# Cloich Forest Wind Farm

Volume 3 – SEI Report Technical Appendices  
(Part 1 of 2)

**TECHNICAL APPENDIX A6.1: POST  
APPLICATION HISTORIC  
ENVIRONMENT SCOTLAND  
CONSULTATION**

## **Proposed Cloich Forest Wind Farm: Applicant Response to HES Objection**

### **Figure A1: SM2755 Whaup Law Cairn T8 Comparison (180 degree field of view)**

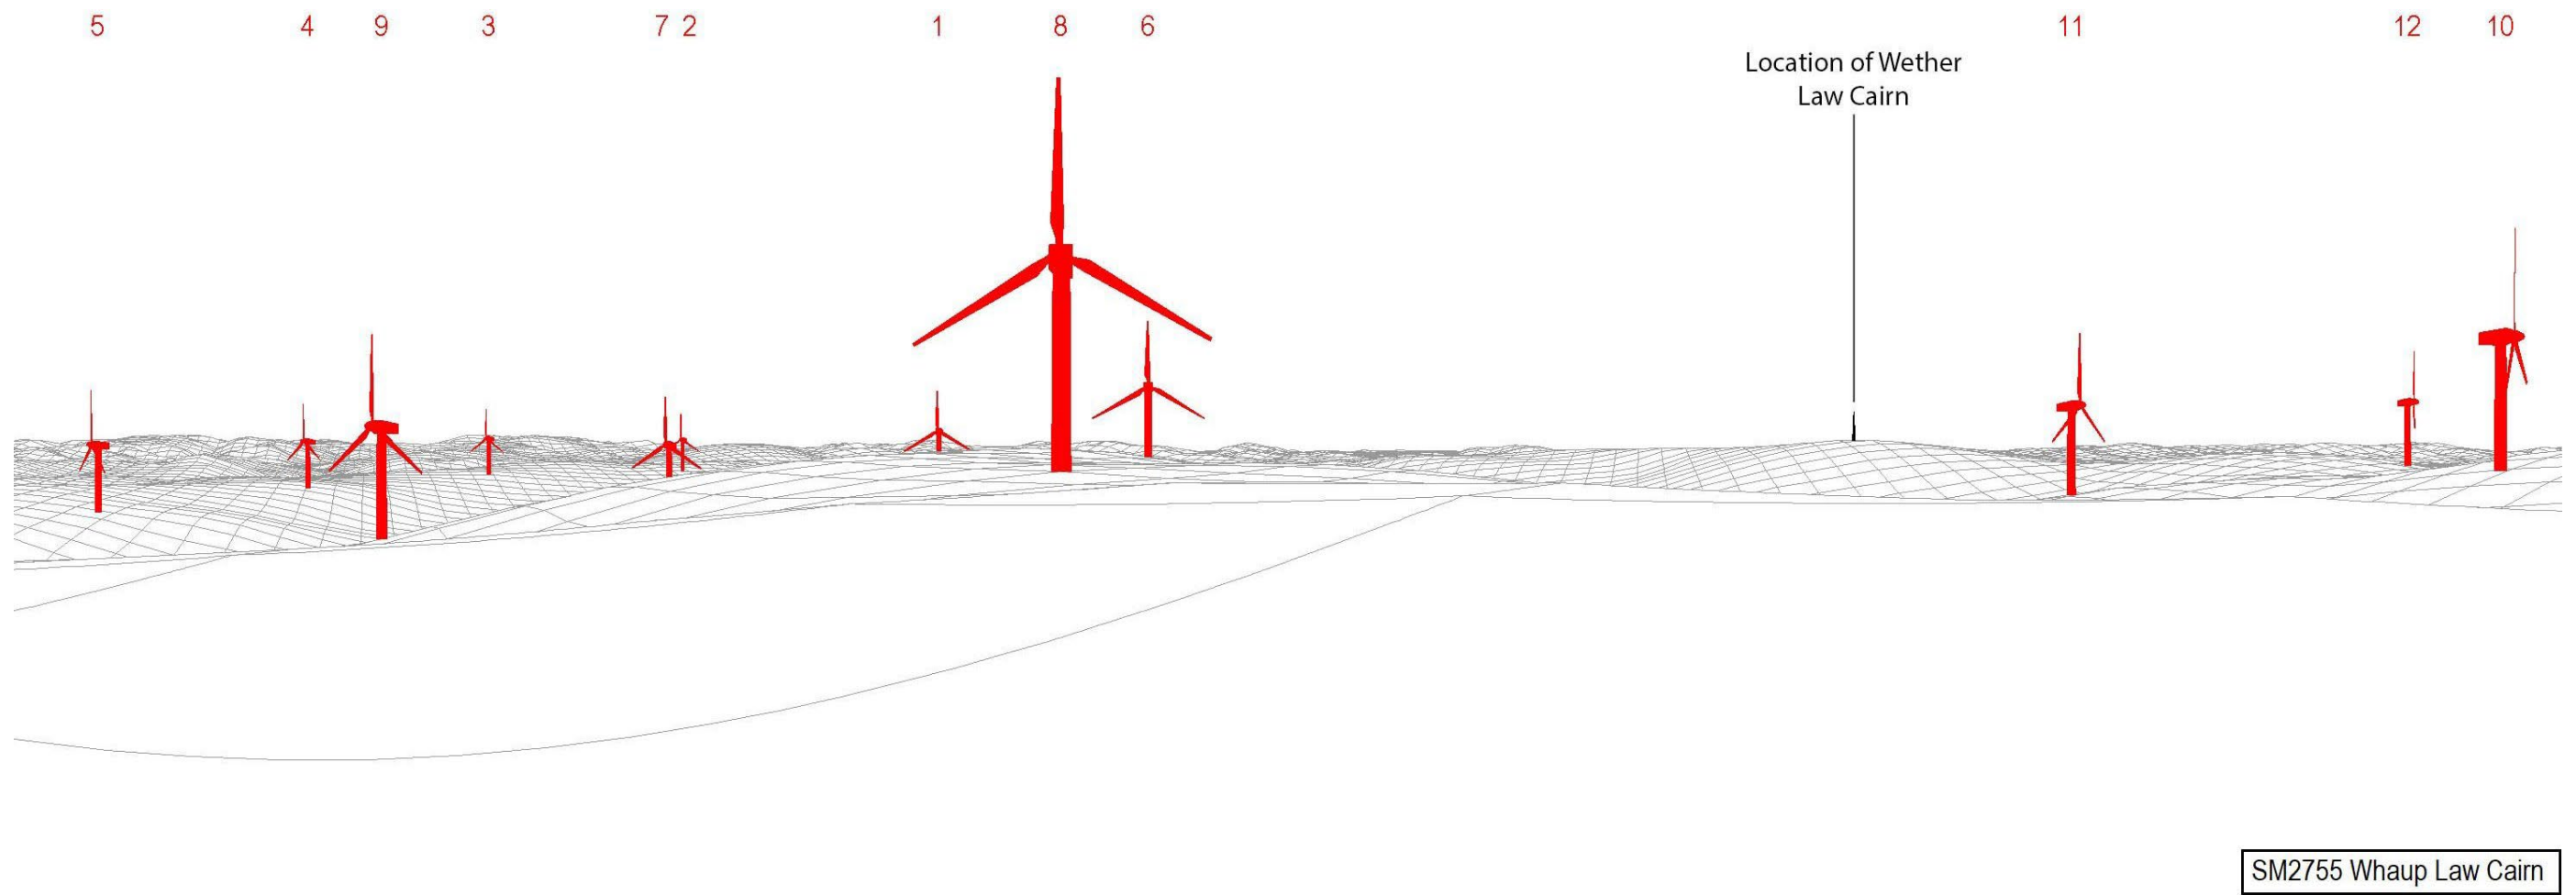
In HES's consultation response, dated 16 September 2021, an objection was lodged due to setting impacts, caused by T8, on Whaup Law Cairn, designated as a scheduled monument (SM2755). HES noted in their response,

In the original location, it is acknowledged that, whilst not within the direct sightline from Whaup Law Cairn to Whether Law Cairn, T8 is within close proximity to SM2755. **Technical Appendix A6.3: Setting Assessment of Chapter 6: Archaeology & Cultural Heritage** of the EIA

Through the relocation of T8 the proposed turbine position is now a further 100 m away (300 m in total) from the scheduled monument and located further south. Figures A1 to A4 show that the relocated T8 would be further away from the cairn and less prominent, as it no longer shares the hill summit with the monument. This is a marked improvement to the layout, enabling Whaup Law Cairn to be the dominant feature upon the hill top with the turbines a slightly more distant and separate component visible above the forestry treeline. The relocation to the south-west has also increased the gap between T8/T6 to the south and T11 to the north so that there is a wider field of view / viewshed available between Whaup Law and Wether Law Cairns as shown in Figures A1 & A2.

The relocation of turbine 8 as demonstrated in your consultation should allow us to remove our objection to the scheme, based on the information we have available. The new location proposed for Turbine 8 is similar to that of Turbine 9 of the previous (consented) scheme; a little higher in elevation and taller, but slightly further way from the monument. The potential setting impacts on the cairn from the current proposal are therefore likely to be very similar to that from the earlier consented scheme. We do not consider this impact to raise issues in the national interest and therefore would not object to the revised proposals.
